Rezoning Transportation Analysis

Petition Number: 2026-011

General Location Identifier: 05109134

Date	Description
03-26-26	First Review (BH)
04-23-26	Second Review (BH)
07-23-26	Third Review (BH)

~~6+ Boulevard with Shared Used Path (Charlotte Streets Map)~~

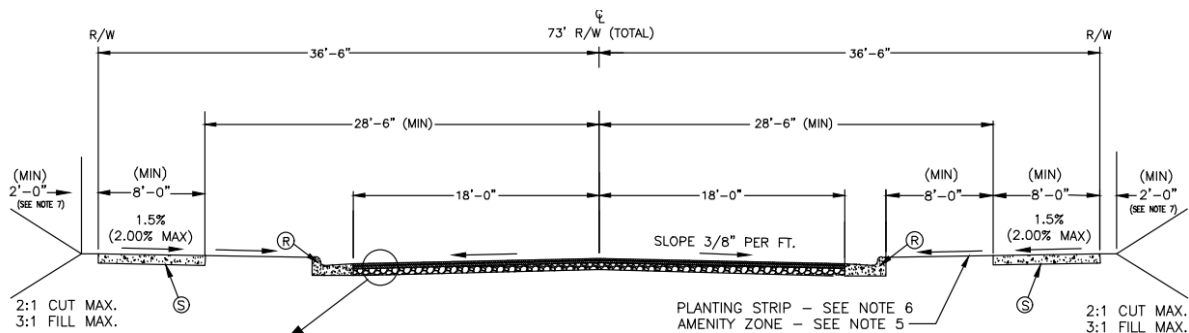
- a. ~~N Tryon St:~~ Location of future back of curb and gutter is to be shown at 44 feet from road centerline and must be shown in the future location according to UDO Article 32.7.

~~Label and dimension the existing and future curb and gutter from the centerline for each road on the site plan.~~

PROPOSED CALDWELL ROAD EXTENSION SECTION

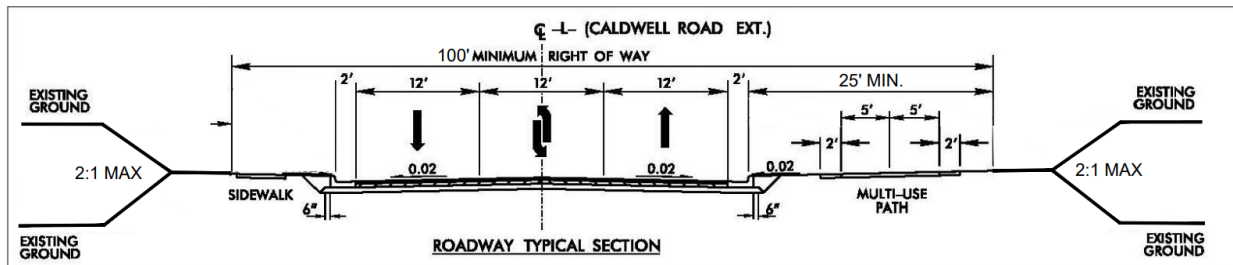
c. ~~Caldwell Road Extension:~~ Location of back of curb and gutter is to be shown according to approved project (Accela Project # LDGP-2025-00071/RZP-2021-150).

~~Label and dimension the curb and gutter from the centerline for each road on the site plan.~~

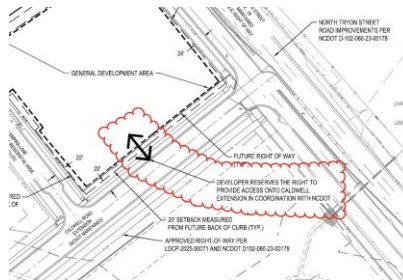
3. **New Comment 7/22/2026:** Update note per new comments to include:

- Hudspeth Northbound U-turn (half signal)
- Caldwell Road Extension Southbound Leftover (half signal)

h. PETITIONER SHALL COMPLETE THE FOLLOWING IMPROVEMENTS AS OUTLINED IN THE APPROVED TRAFFIC IMPACT STUDY (TIS) IN COORDINATION WITH CDOT AND NCDOT, OR OTHER COMPARABLE IMPROVEMENT(S) AS MUTUALLY AGREED WITH CDOT AND NCDOT:

h.a. AT THE INTERSECTION OF US-29 (NORTH TRYON STREET) AND HUDSPETH ROAD, PETITIONER SHALL PROVIDE A NORTHBOUND U-TURN BULB WITHIN THE EXISTING RIGHT-OF-WAY FOR PASSENGER VEHICLES VIA THE DIRECTIONAL CROSSOVER MEDIAN COMMITTED TO IN APPROVED REZONING PETITION RZP-2021-150. TRUCKS, BUSES, AND OTHER LARGER NON-PASSENGER VEHICLES WILL BE RESTRICTED FROM THE U-TURN BULB VIA SIGNAGE.
